RFI #27 - Manafort would like a detail for the berm between the parking lots and the sidewalks. This Berm is not what industry standard for this application. A traditional 6" asphalt Berm would be more appropriate and would work as a wheel stop in this situation

JOB 10-20-2006  
SHEET NO. 1 OF 1  
CALCULATED BY HA DATE 2/1  
CHECKED BY N/A DATE   
SCALE N/A

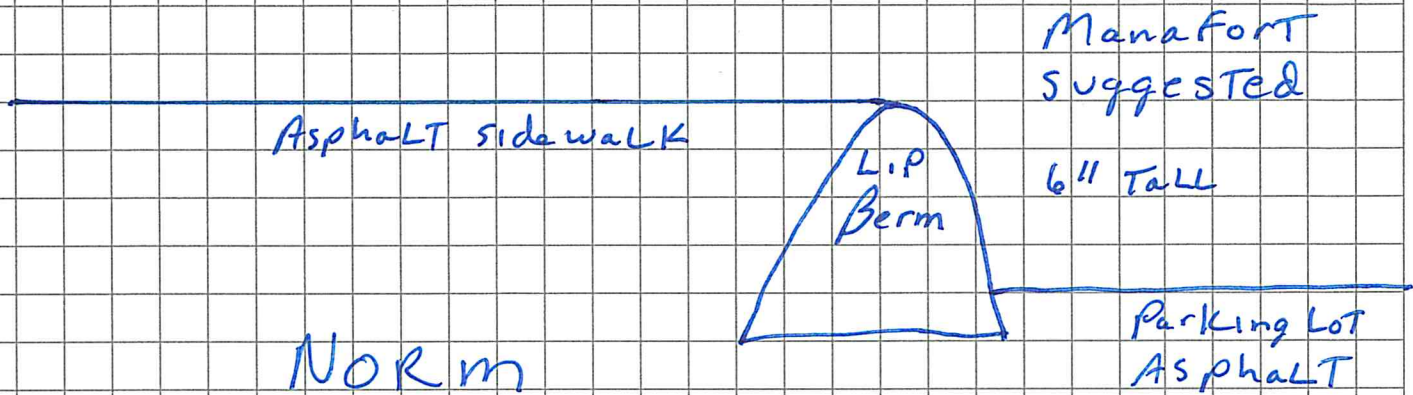
acts as Car Wheel STOP

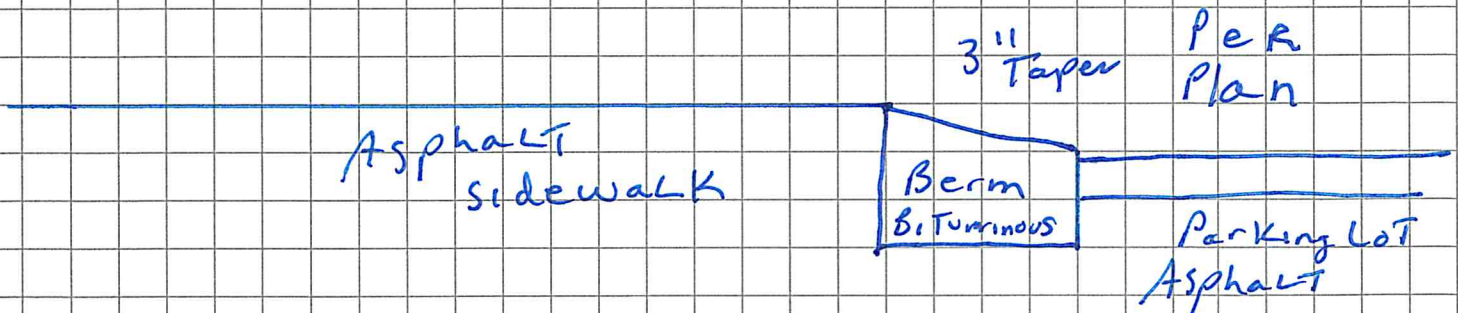
Has No Wheel STOP ability
